EAGLE MOUNTAIN
PLANNING COMMISSION MEETING

FEBRUARY 11, 2025, 5:30 PM
EAGLE MOUNTAIN CITY COUNCIL CHAMBERS
1650 EAST STAGECOACH RUN, EAGLE MOUNTAIN, UTAH 84005

EAGLE MOUNTAIN CITY **PLANNING COMMISSION MEETING** **FEBRUARY 11, 2025**
TITLE:	Parkway Fields Subdivision Preliminary Plat H Approval Request
ITEM TYPE:	Preliminary Plat
FISCAL IMPACT:	n/a
APPLICANT:	Flagship Homes, Luke McColm representing

EAGLE MOUNTAIN CITY **PLANNING COMMISSION MEETING** **FEBRUARY 11, 2025**
TITLE:	Pinnacles B-3 project - Master Site Plan and Preliminary Plat
ITEM TYPE:	Master Site Plan
FISCAL IMPACT:	n/a
APPLICANT:	Century Communities; Toby Cordova representing

SHEET 201

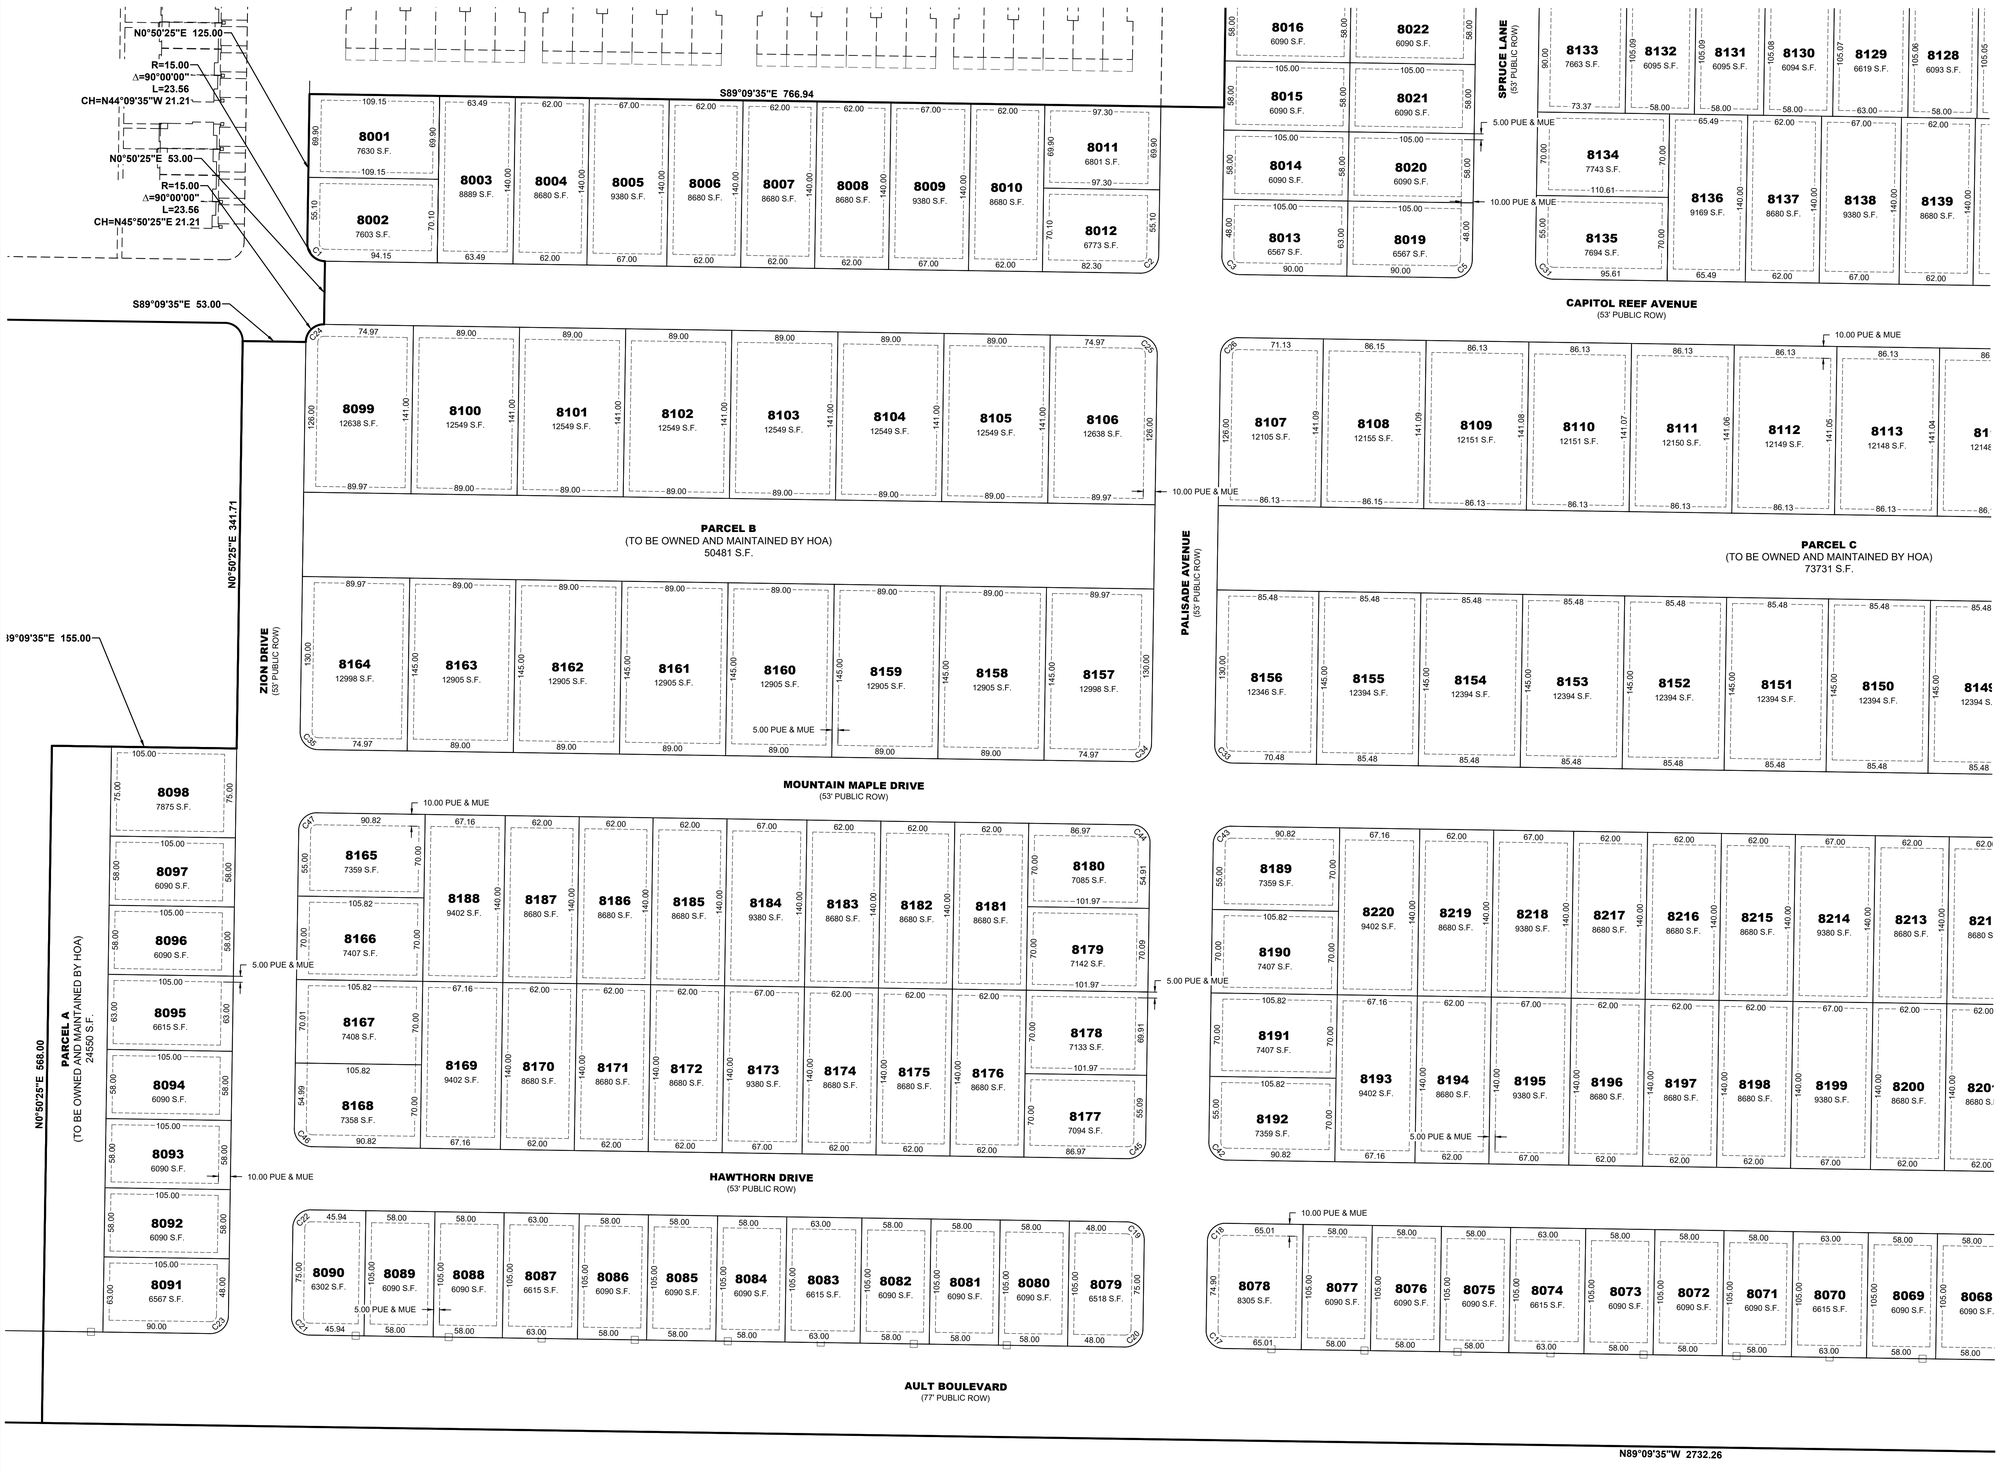
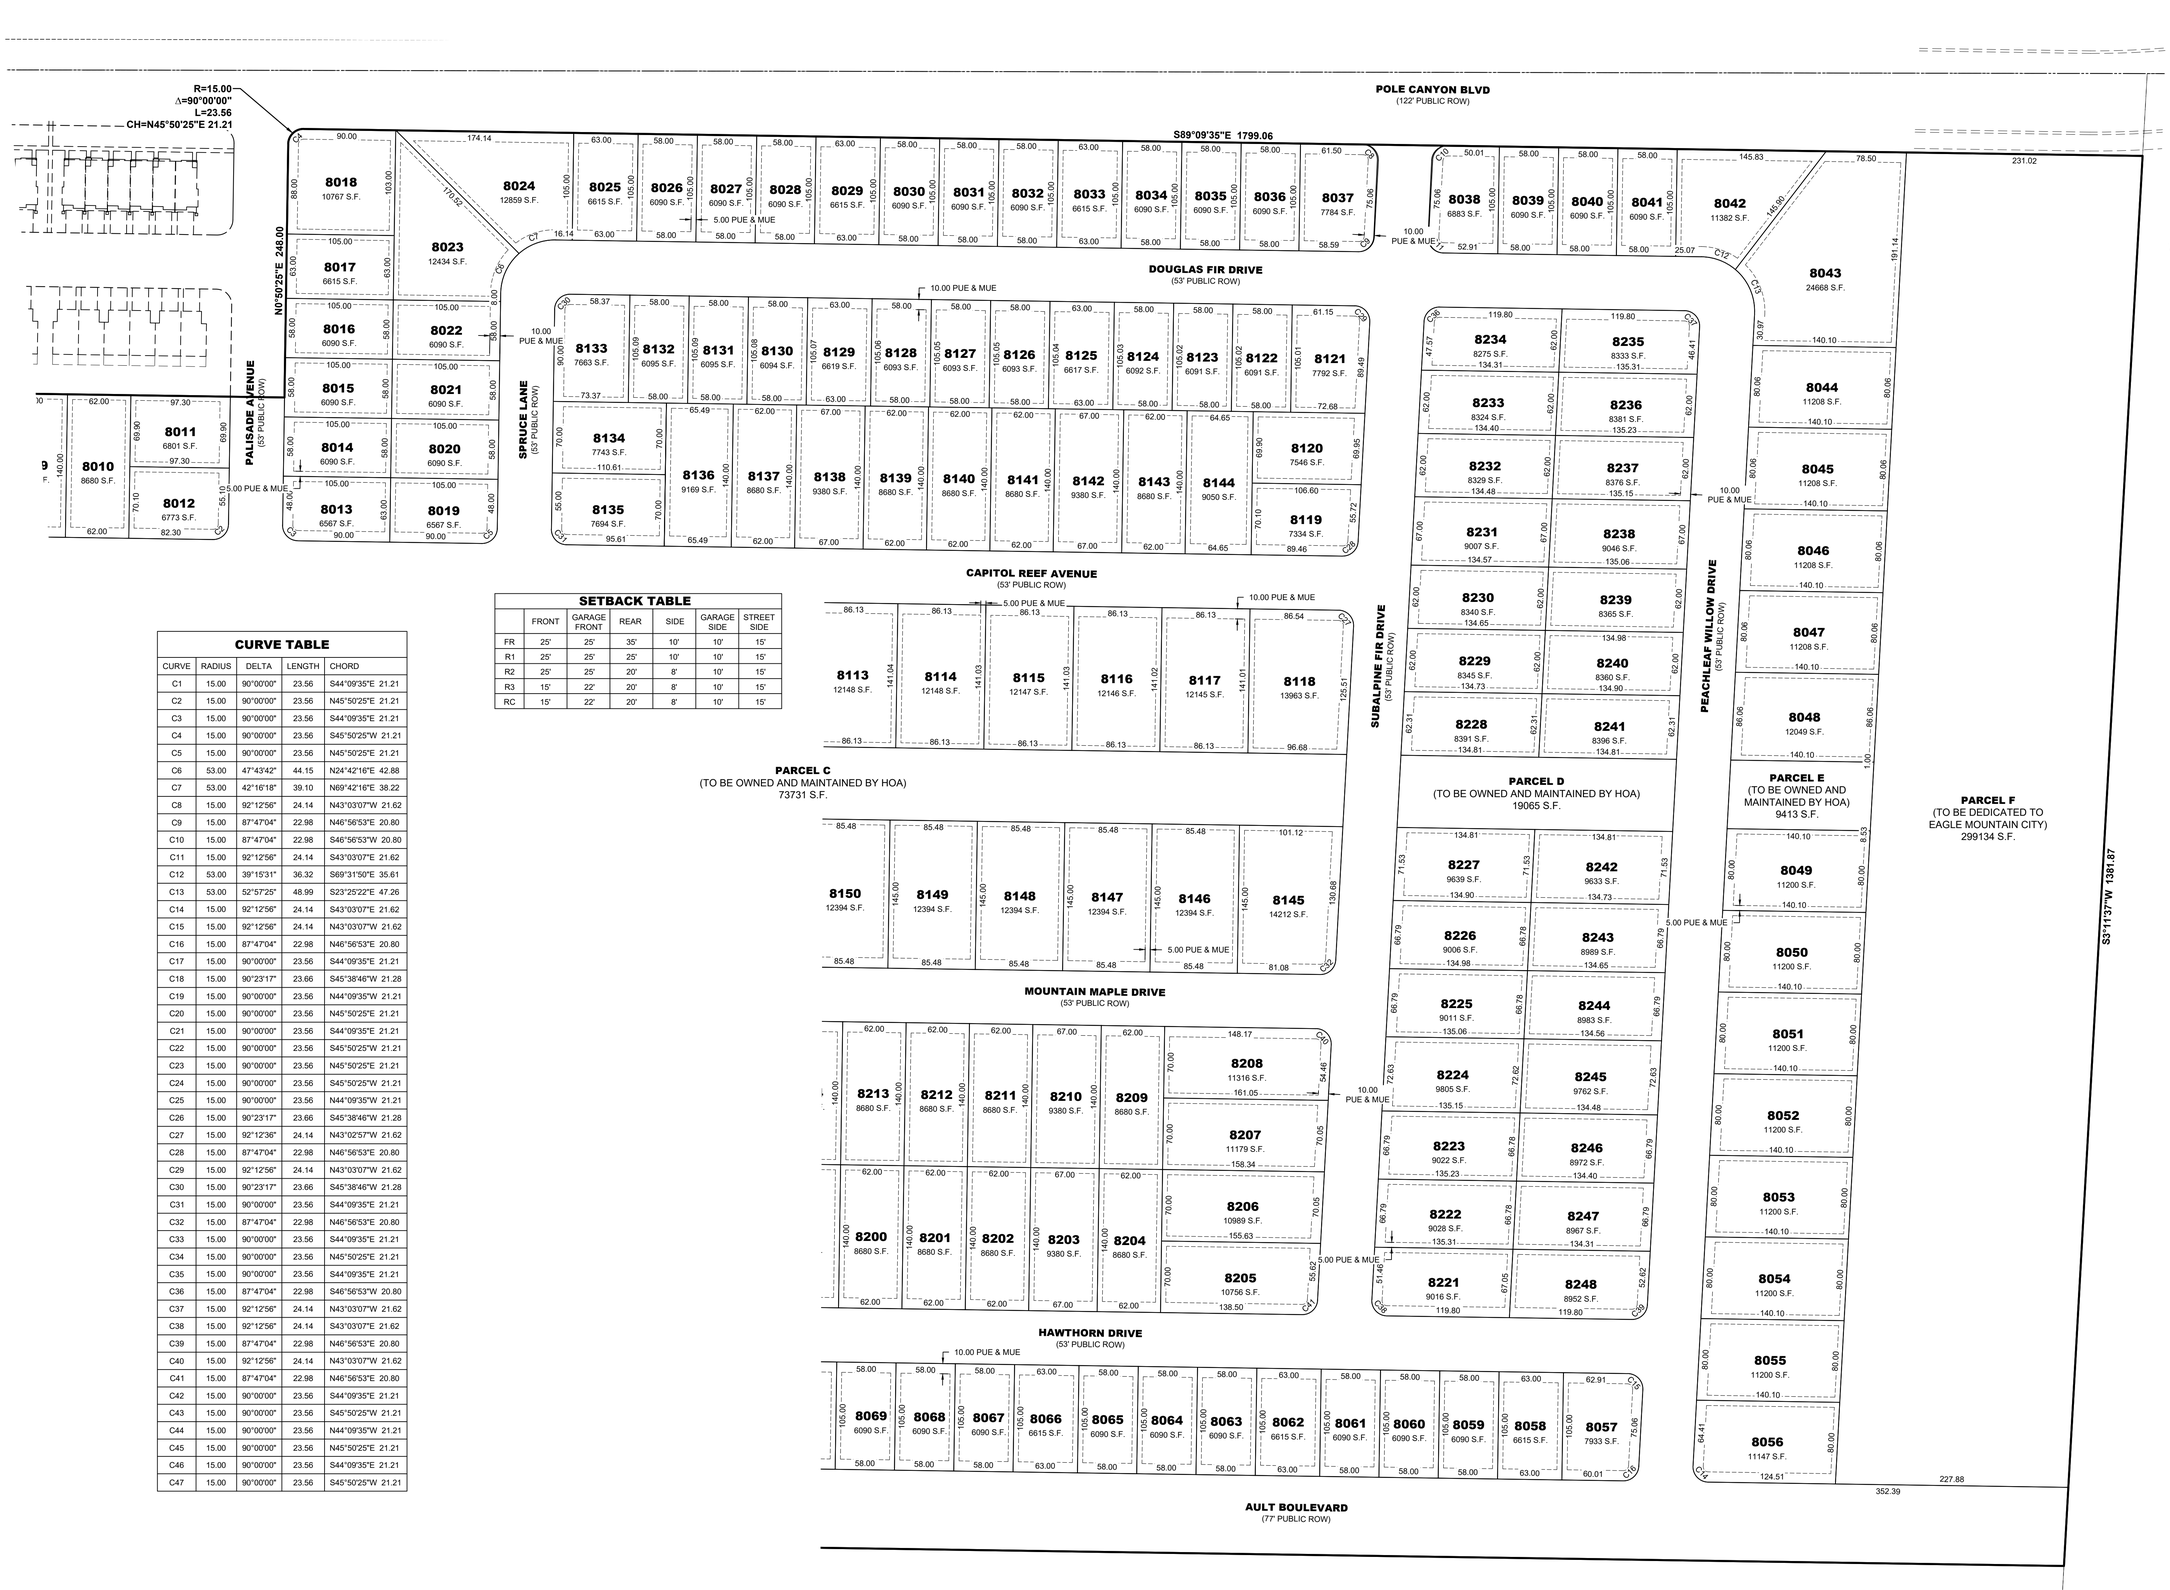
RsOW: Rights-of-way width(s) and alignment and dedication needs have been evaluated and changes made to plat drawings to accommodate DRC comments. Rights-of-way are mapped to match the approved master development plan layout for the Project. Public street widths/profiles are as per approved Ault Farms Development Agreement terms and standards. They are shown with widths that were code approved at the time Ault Farms was entitled and vested (e.g., 53' wide local streets).

Connectivity Index Required: RC zoned area = 1.75. R2 zoned area = 1.6. R3 zoned area = 1.6. Provided: 1.375 RC, .875 R2, .92R3. Regardless, it should be noted that the street pattern follows the approved Master Plan which trumps. And the code should probably be updated to read the index as a maximum not minium requirement if nodes are deemed desirable.
